NOTICE OF VIOLATION

Violation 1. Energy Safety observed that in implementing 2024 WMP initiative 8.1.3.1 - Distribution Detailed Inspections and Remediations (IN-1.1), SCE failed to complete remediation of a buried down guy anchor on pole ID 4263497E, Grid Hardening ID 413733488-4263497E, at coordinates 34.375031, -118.542017. Energy Safety considers this completeness violation to be in the Moderate risk category.

INSPECTION REPORT

Exhibit A: Photo Log **Structure ID:** 4263497E Violation 1

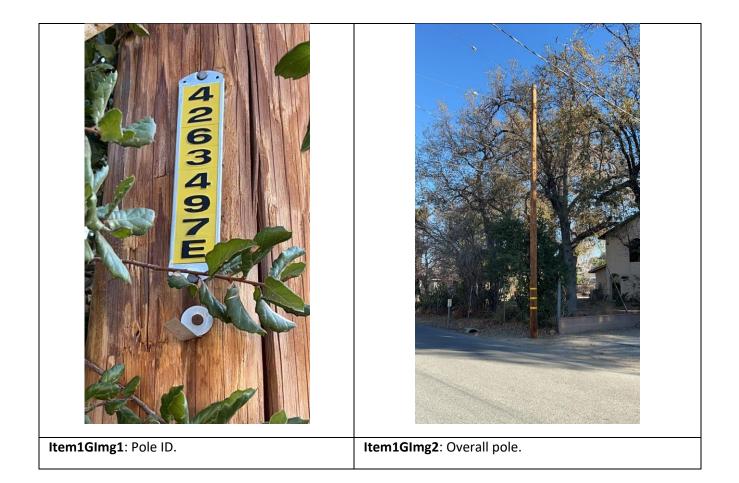
- 1. The anchor head was observed below grade.
- 2. The automatic is not secured to the anchor eye.
- 3. The existing anchor shows significant signs of corrosion.
- 4. The supporting guy anchor of the subject pole is located within HFTD 3 and a heavily trafficked residential neighborhood.
- 5. The anchor remediation was reported as completed on May 9, 2024. Should extreme winds or other environmental conditions occur, the guy anchor rod is more likely to fail.

Item1IA1Img1: Observed buried guy anchor below grade.	Item1IA1Img2 : Down guy wire preform is connected to an automatic and not directly to the down guy anchor eye. The automatic is connected to an existing severed down guy loop fastened together by a three-bolt clamp.
Item1IA1Img3 : Close up of excavated anchor head below grade.	Item1IA1Img4: Severed pre-existing down guy loop fastened by a three-bolt clamp.

- 4.2 For new installations, the following applies:
 - . The bottom of the eye shall be 4 inches minimum to 18 inches maximum above grade.
